Access Compliance Report

Public Rights-of-Way

Intersection ID: 28715	Main Street: EAGLE_CREEK_DR	Cross Street: DELAMERE_LN	Location:	N
ADA ID: DFC5716325E4	Ramp Type: PerpDiag	Initial Pass/Fail: Fail	Overall Compliance: No	Severity Score: 12.5

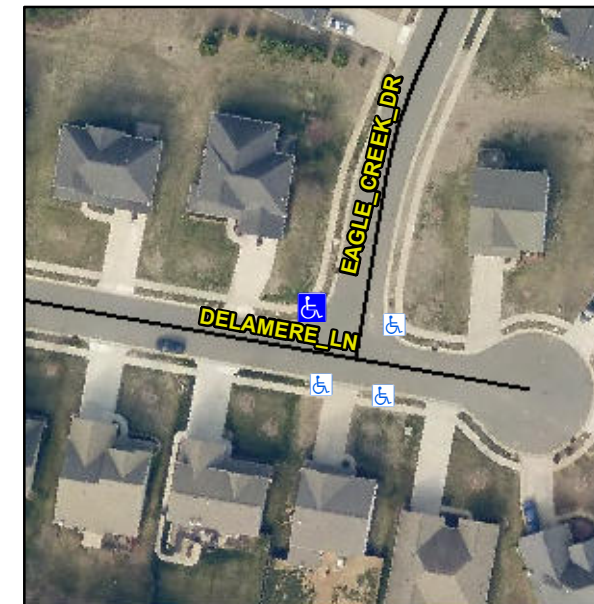
Not Found, R304.2.2

Compliance	Description	Data	Compliance	Description	Data
N/A	Ramp Length (in)	48.0	No	Ramp Slope (%)	11.2
Yes	Ramp Width (in)	48.0	Yes	Ramp XSlope (%)	1.0
N/A	Flare Type LT	N/A	N/A	Flare Type RT	N/A
N/A	Flare Slope LT (%)	N/A	N/A	Flare Slope RT (%)	N/A
N/A	Flare Traversable LT?	N/A	N/A	Flare Traversable RT?	N/A
N/A	Landing Length (in)	N/A	N/A	DWS Provided?	N/A
N/A	Landing Width (in)	N/A	N/A	DWS Contrast?	N/A
N/A	Landing Slope (%)	N/A	N/A	DWS Length (in)	N/A
N/A	Landing X Slope (%)	N/A	N/A	DWS Full Width?	N/A
N/A	Landing Curb? (Y/N)	N/A	N/A	DWS Offset (in)	N/A
N/A	Shared Landing?	N/A			
N/A	Gutter Ponding?	N/A	N/A	Gutter Slope (%)	N/A
N/A	Gutter Lip Ht (in)	N/A	N/A	Gutter X Slope (%)	N/A
N/A	Painted X Walk1?	No	N/A	Painted X Walk2?	No
	X Walk 1 Direction	To S		X Walk 2 Direction	To E
N/A	X Walk 1 Width (in)	N/A	N/A	X Walk 2 Width (in)	N/A
	X Walk 1 Slope (%)	1.9		X Walk 2 Slope (%)	2.7
	X Walk 1 X Slope (%)	2.1		X Walk 2 X Slope (%)	2.9

Remove & Replace Curb Ramp With Two New Directional Ramps or Equivalent.
